| Project | IEEE 802.16 Broadband Wireless Access Working Group < http://ieee802.org/16 > | |
| Title | Enhancement of DL Map transmission with STC in the first mandatory PUSC zone | |
| Re: | Response to Sponsor Ballot on IEEE802.16e/D6 document | |

Enhancement of DL Map transmission with STC in the first mandatory PUSC zone

Figure xxx- Cluster structure for First-zone STC.

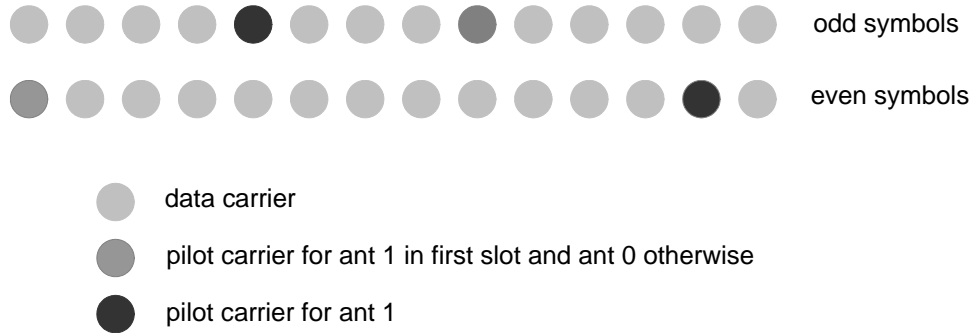
[Add Section 8.4.8.1.2.1.3]

8.4.8.1.2.1.3 First-zone STC modulation using 2 antennae in PUSC

The clusters comprising the subchannels used by the First-zone STC modulation shall be allocated and subcarriers numbered as defined in 8.4.6.1.2.1. The cluster structure is depicted in Figure xxx. With an exception of FCH subchannels, encoding of the First-zone STC is depicted in Figure yyy. The FCH subchannels shall not be STC encoded. The First-zone STC mode is enabled via Coding Indication contained in the DL Frame Prefix (8.4.4.3). For preamble symbols and FCH subchannels transmission, antenna 1 transmits null data in the corresponding data tones. Demodulation of DL Frame Prefix that contained in FCH subchannels is thereby unaffected from the single-antenna TX configuration and is fully compatible with the mandatory PUSC modulation.

Figure yyy. Encoding of STC for use with First-zone PUSC.

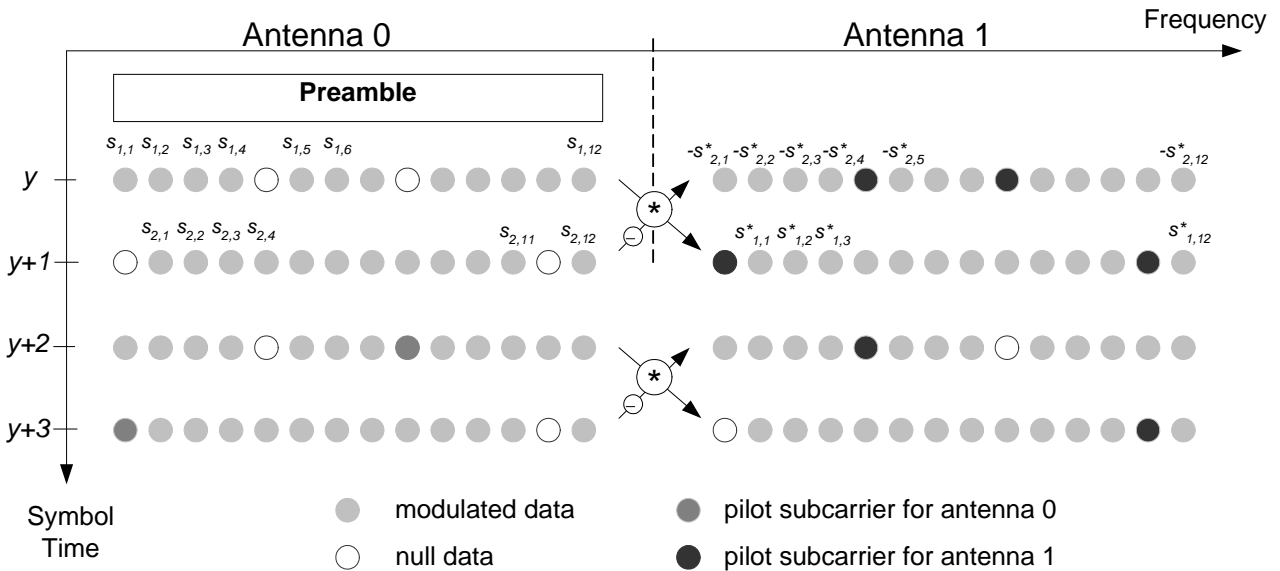
The pilot tones in the first slot (first two OFDMA symbols after the preamble symbol) shall be transmitted by antenna 1 for use in channel estimation. Thereafter the pilot tones are divided between antenna 0 and 1. Modulation of pilot tones are depicted in Figure yyy.
